RAINIER SQUARE REDEVELOPMENT RECOMMENDATION MEETING

Design Review Submittal # 2

Address: 1301 5th Ave., Seattle, WA 98101

DRB #2 Review Date: June 23, 2015

D.1 Relationship to Existing Rainier

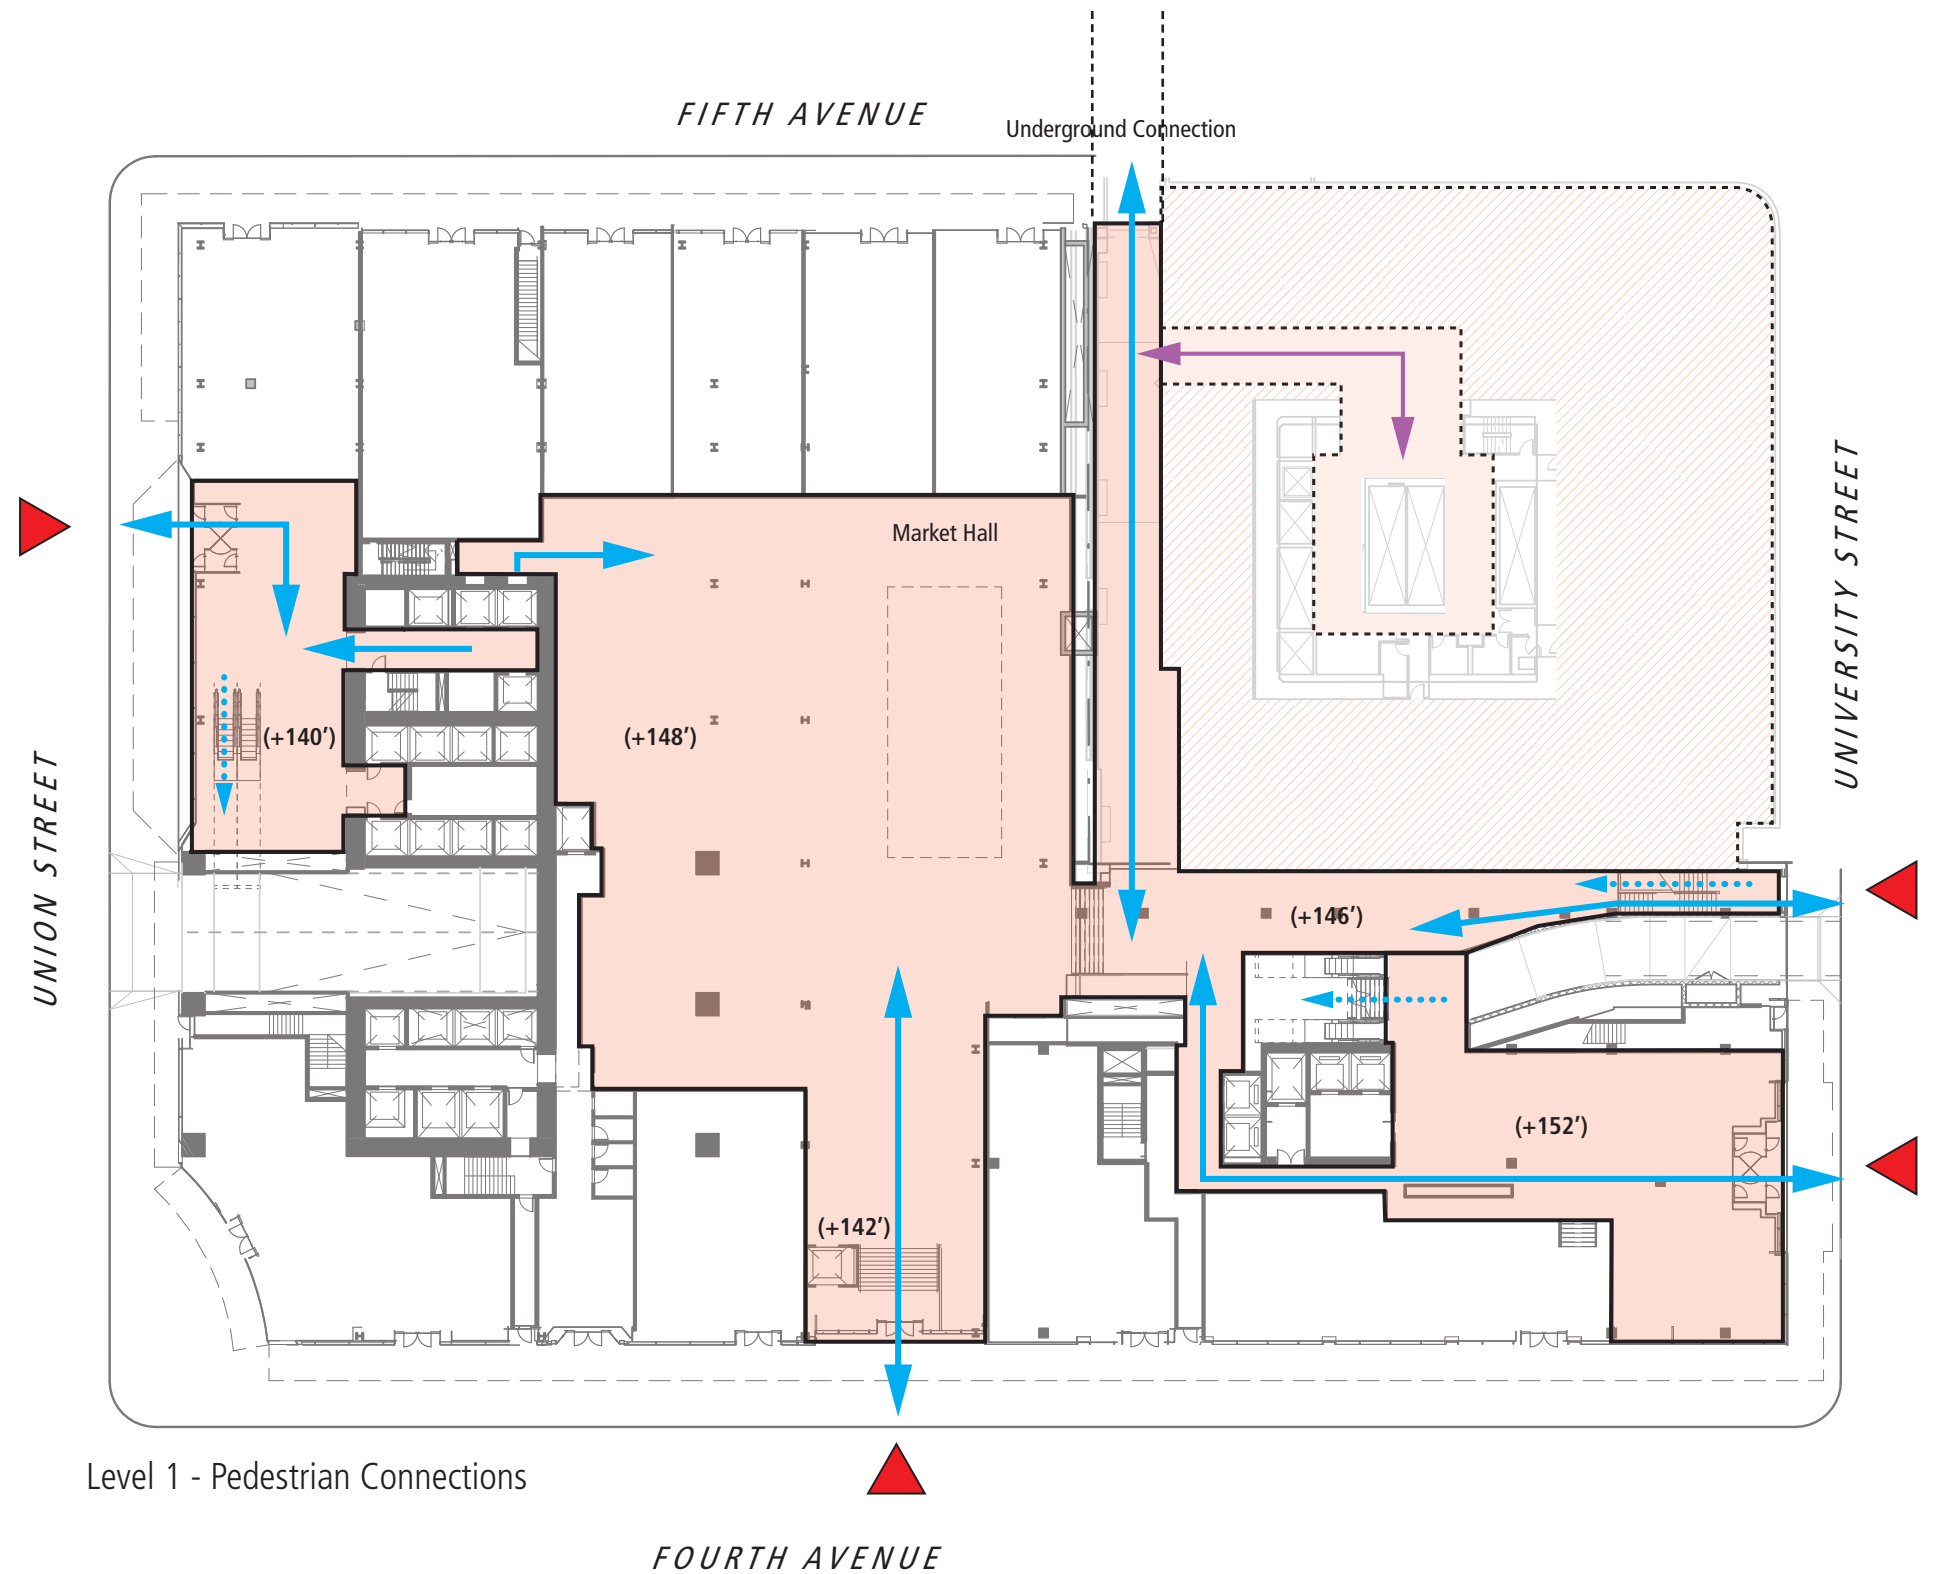
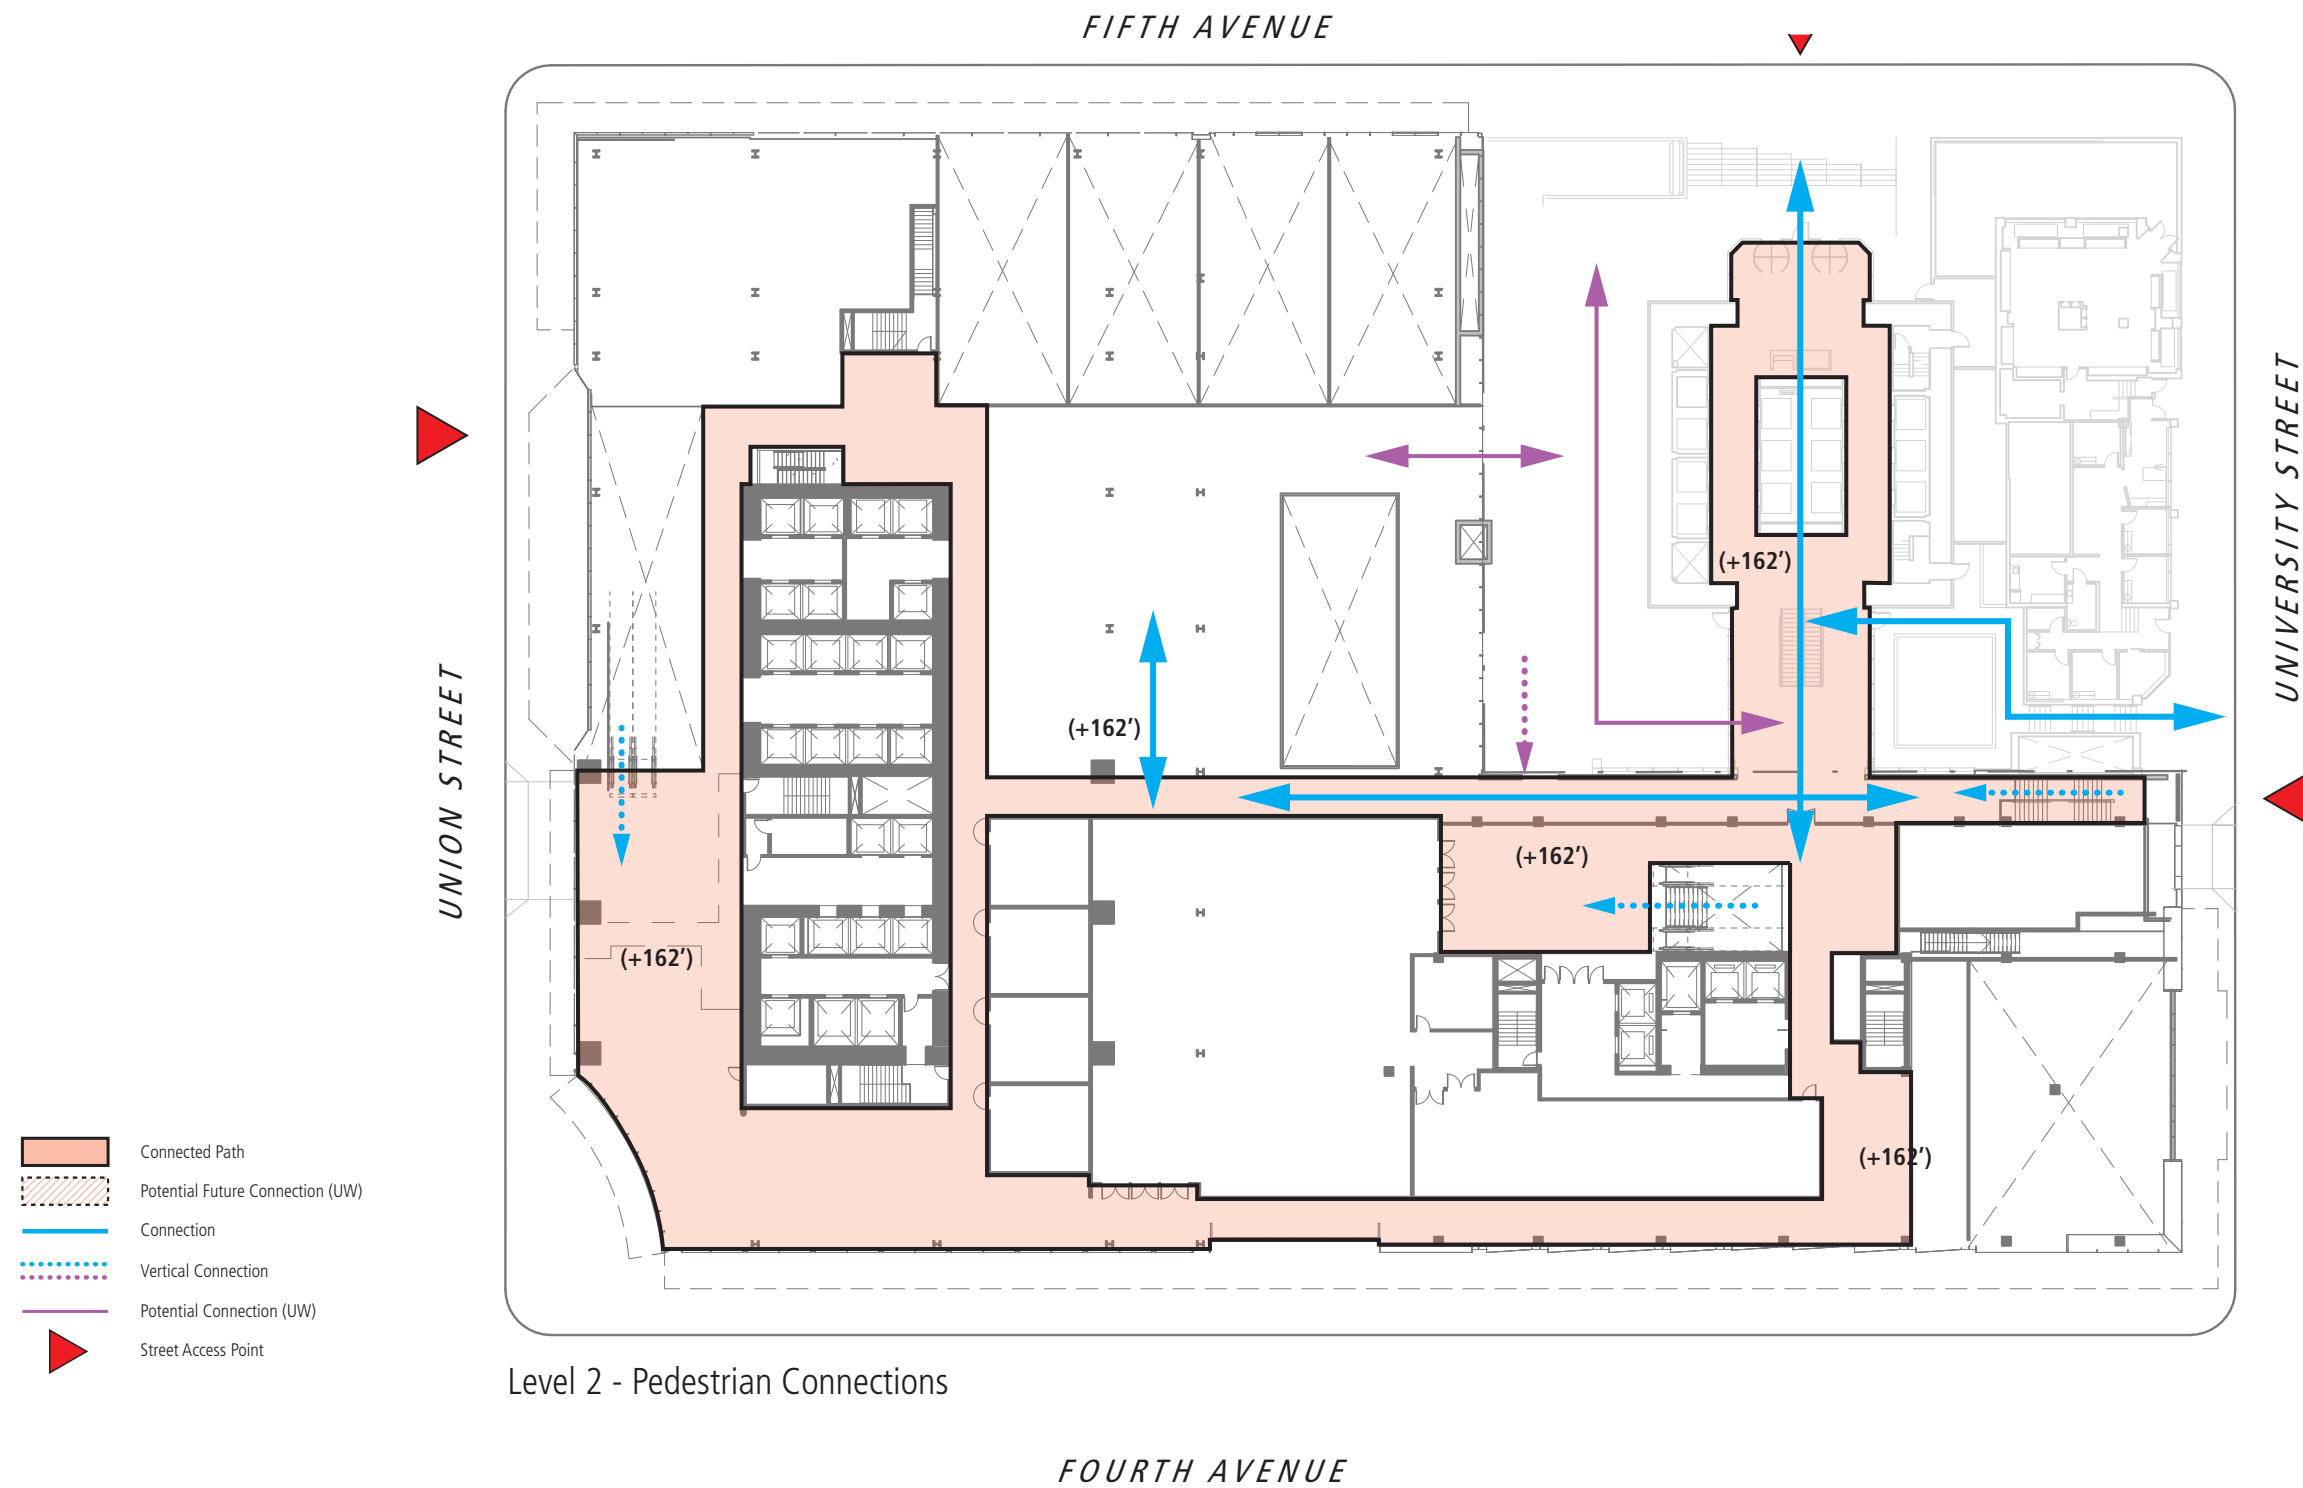
The design of the rooftop above the second floor, which wraps the Rainier Tower's perimeter on the north and west, feels piecemeal according to the Board. It does little to engage the landscaping surrounding the tower and at street level. The size and shape of the skylight above the atrium nearly cuts off the users' ability to circulate within the outdoor area. The landscape gestures forming this outdoor plaza need refinement to produce a sense of place. The Board noted that any new spaces created at the lower levels should be well integrated into the overall landscape design.

- The proposed design provides a multitude of interconnected spaces accessible to customers, tenants, guests and the public during business hours, in addition to extensive retail streetfront spaces. See circulation diagrams on the following pages. Connections between the new development, the existing pedestrian tunnel under 5th Avenue, sidewalk entrances, and the existing Rainier Tower lobby have been carefully considered.
- Skylight areas over the second level retail spaces have been reduced at the request of the Board to improve circulation and outdoor open spaces at the Level 3 Roof Deck areas.
